PLAN COMMISSION STAFF REPORT

Meeting Date: June 14, 2022

Agenda Item: PC Docket No. 22-007

Summary: Paul Kats on behalf of Munster Church, Inc. requesting of a development plan to permit the construction of an addition to the Munster Church, the construction of a new multipurpose accessory building, and associated site modifications at 214 Ridge Road.

Figure 4 Building facade position shown in red; Ridge Road Frontage line shown in blue

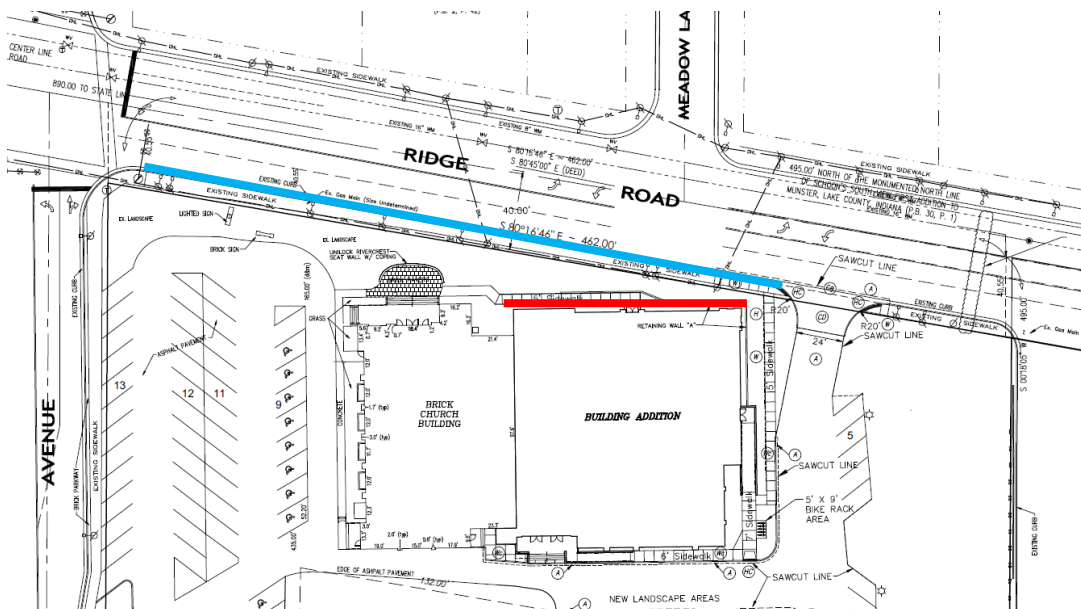
1. TABLE 26-6.405.B CIVIC ZONE STANDARDS Façade Position – required to be parallel to straight Frontage Line or to tangent of curved Frontage Line.

Required: The proposed building addition must be positioned parallel to Ridge Road

Proposed: The proposed building addition is positioned on a straight east-west line.

Figure 7 Portions of parking lot not meeting minimum illumination standard

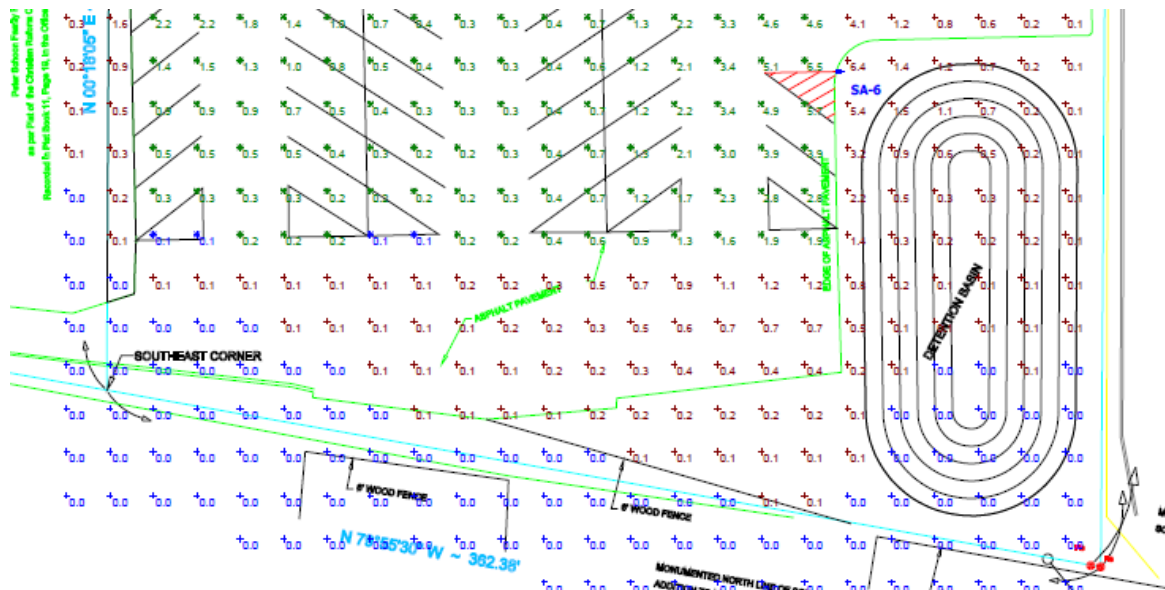
Required: Described above.

Proposed: Areas along the south edge of the east parking lot are illuminated at a level less than 0.4 foot-candles.

Figure 9 Location of new landscape islands.

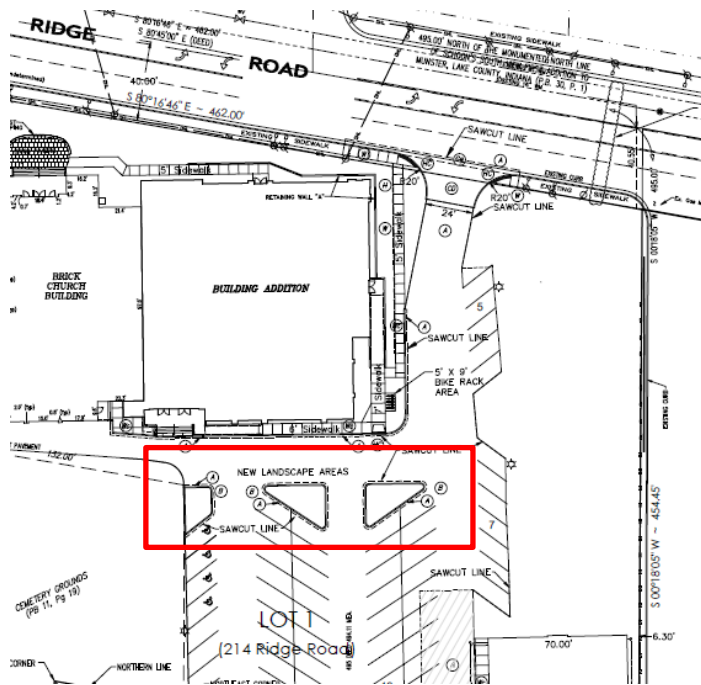
Required: Landscape islands are required to be installed in existing parking lots when a new building is constructed, but the requirement can be waived if they can't be installed without removing required parking spaces. In this case, there are 18 existing areas at the ends of parking rows that can be converted from asphalt to landscape islands.

Proposed: Only three new landscape islands are proposed south of the building addition.

MUNSTER CHRISTIAN REFORMED CHURCH
214 RIDGE ROAD, MUNSTER, IN 46321
SITE PLAN

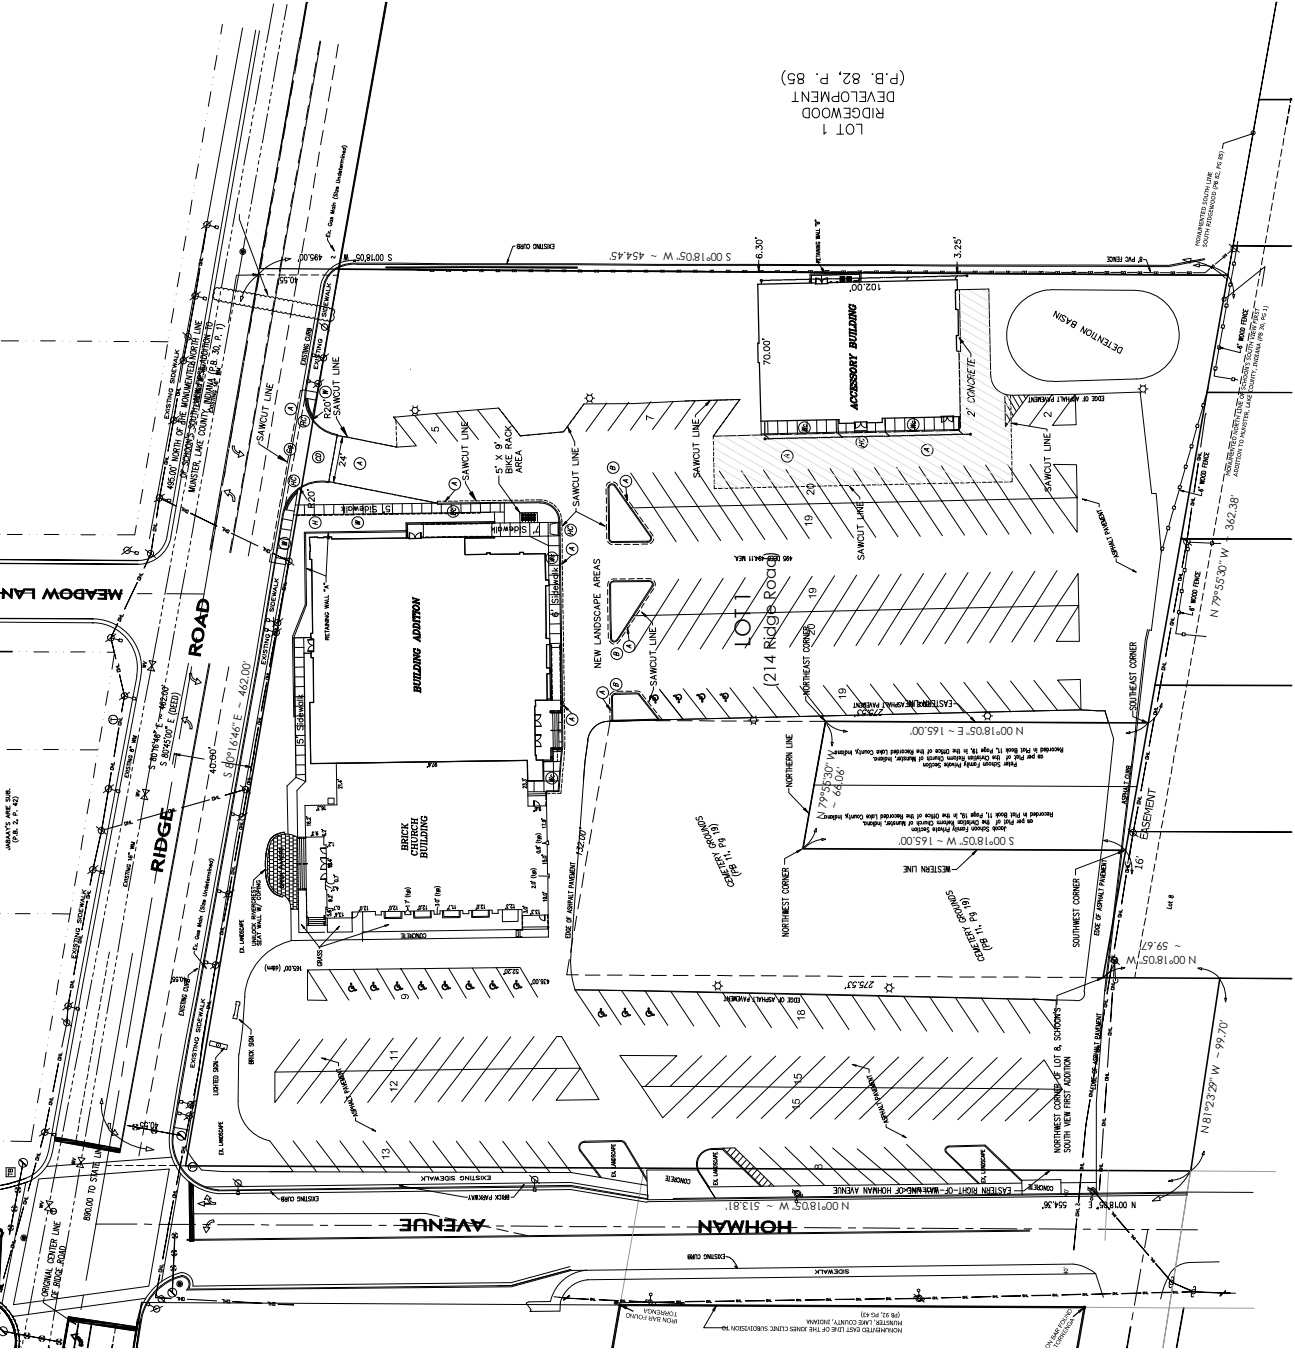
1. TABLE 26-6.405.O-1 VEHICULAR PARKING REQUIREMENTS Place of Worship: 1 per 3 auditorium seats + adequate bus space for activities of institution + passenger loading space. **Number of seats in church not shown on plans. This is needed to determine required parking.**

2. TABLE 26-6.405.O-1 VEHICULAR PARKING REQUIREMENTS Place of Assembly: .3 spaces per capacity determined by Town Fire Chief. **Occupancy of accessory building not shown on plans. This is needed to determine required parking.**

Response: The number of seats in the sanctuary has been added to the Site Plan, Sheet C-2.0, and the required number of spaces has been added as well.

Response: The number of seats in the new accessory building has been added to the Site Plan, Sheet C-2.0, and the required number of spaces has been added as well.

Response: A 5' x 9' bike rack area has been added near the south east corner of the new building addition at the edge of the sidewalk as can be seen on the Site Plan, Sheet C-2.0.

Response: A note has been added to the Site Plan, Sheet C-2.0, that notes that the pitch of the new accessory building's roof is to be 8:12.

EAST ELEVATION

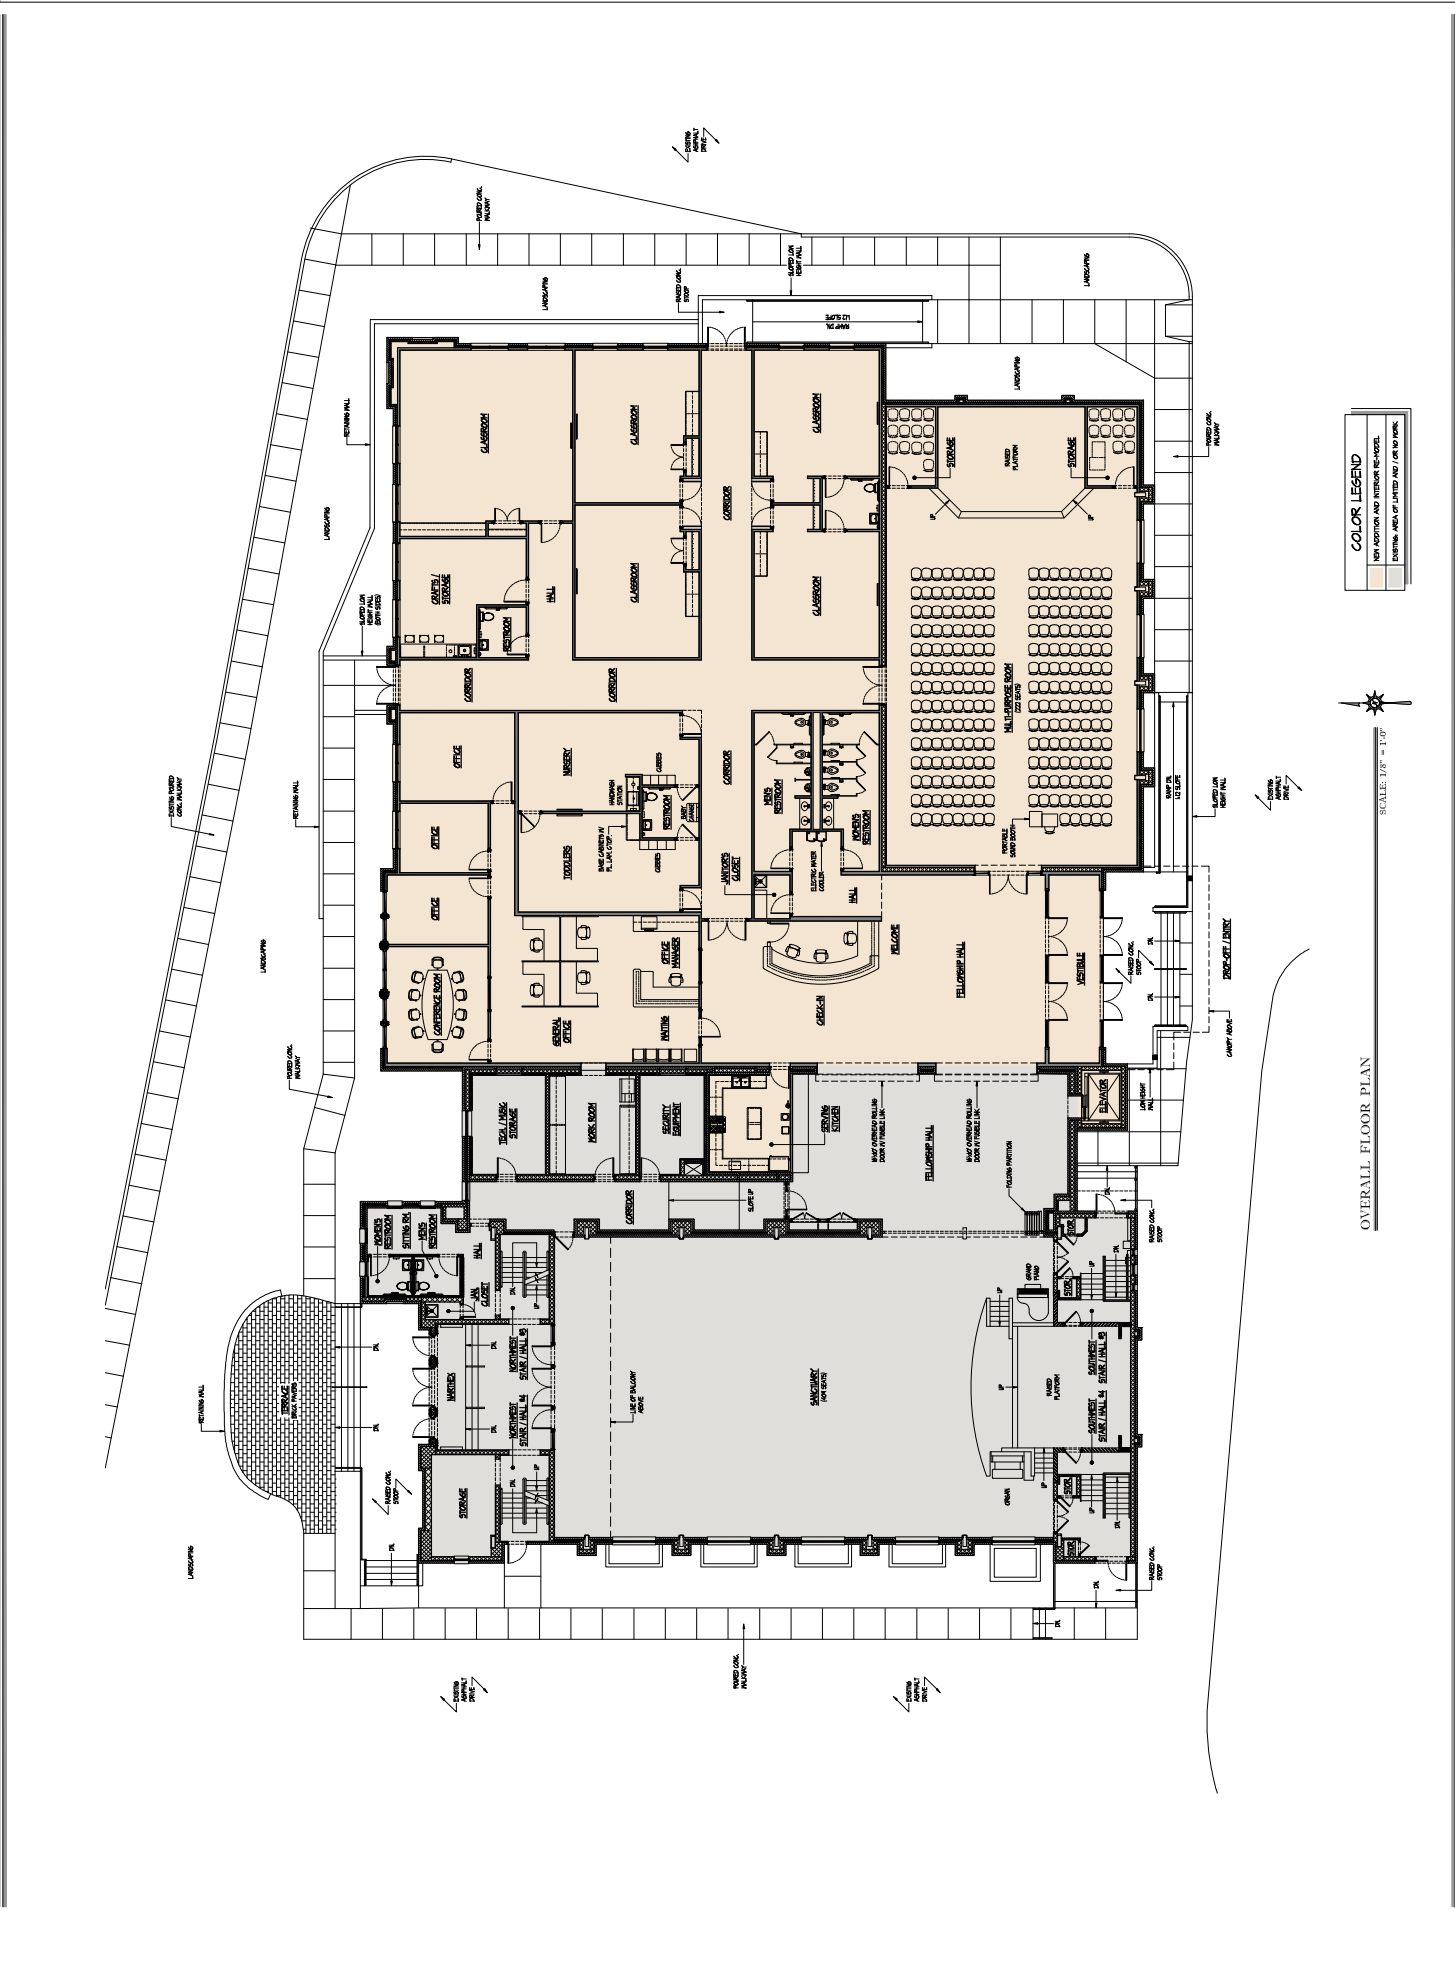
2. TABLE 26-6.405.B CIVIC ZONE STANDARDS Façade Design Proportions - Must be based approximately either on (a) proportions that can be expressed as a fraction using whole numbers (e.g. 1:1, 2:1, 3:2, 4:3, etc) or (b) the following proportions: 1.414:1 or 1.618:1.

Required: The proportions of the proposed building addition either in its entirety or in its individual components must be based on the proportions listed above.

Proposed: The proposed building addition plans include a note: "AVERAGE FAÇADE PROPORTIONS RATIO = 1:4".

Staff comment: It is unclear to staff whether this standard is met and a more detailed response will be required from the architect.

2. TABLE 26-6.405.B CIVIC ZONE STANDARDS Façade Design Proportions - Must be based approximately either on (a) proportions that can be expressed as a fraction using whole numbers (e.g. 1:1, 2:1, 3:2, 4:3, etc) or (b) the following proportions: 1.414:1 or 1.618:1.
Building proportions are not identified on drawings. This is needed to determine if standard is met. Proportion added to exterior elevation sheet

3. TABLE 26-6.405.B CIVIC ZONE STANDARDS Facade Void Area – required to be 20-60% of total Facade area. ***Façade void area calculation is not shown on drawings. This is needed to determine if standard is met.*** Calculations added to exterior elevation sheets. Accessory building compliance is not regulated
